PETITION NO: SLUP-1

PROPOSED USE: Climate Controlled

Self Storage

ZONING COMMENTS:

FRONT ELEVATION
SCALE 1/8" = 1'-0"

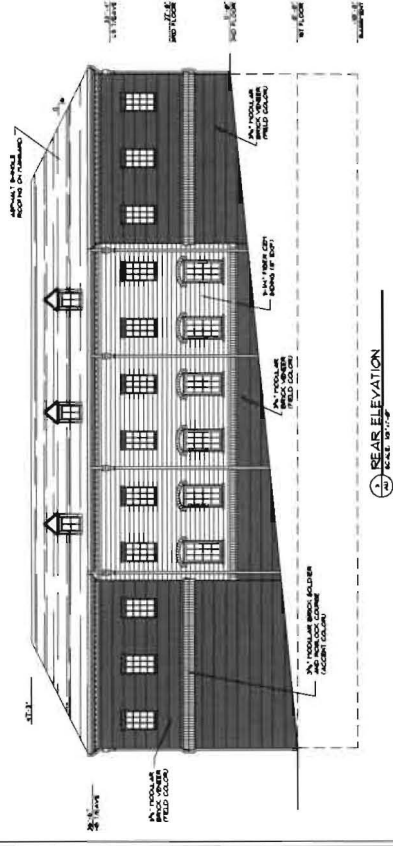
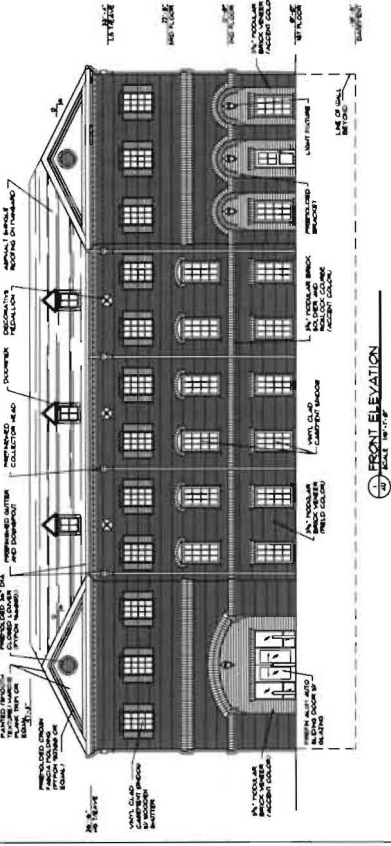
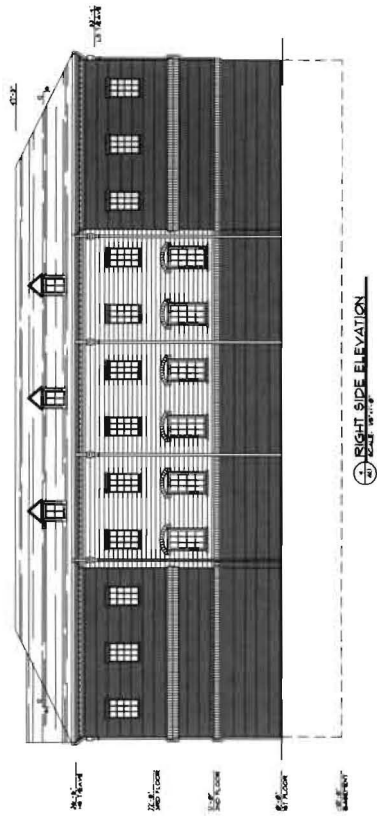
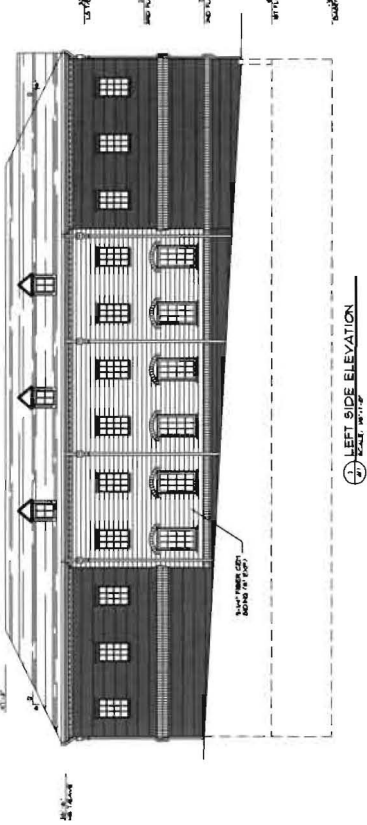
All units are accessed internally, and all windows on the sides of the building are “false windows.” The Code requires that “architectural style/design to be similar or complementary to the predominant architectural design of other commercial uses within the activity center.” The proposed architecture of the storage facility appears to be traditional brick with architectural accents and pitched roof designed to go along with nearby office uses within the activity center of this portion of Roswell Road and Robinson Road that are also traditional style of brick construction. A landscaping plan has been provided which shows a 20 foot landscape buffer adjacent to the residential properties to the south and west as well as landscaping of the frontage.

- Site plan received by the Zoning Division December 4, 2014, with District Commissioner approving minor modifications;
- All windows on residential sides of the building be false windows;
- District Commissioner approving landscape plan and final building architecture;
- Water and Sewer Division comments and recommendations;
- Fire Departments comments and recommendations;
- Stormwater Management comments and recommendations;
- Department of Transportation comments and recommendations.
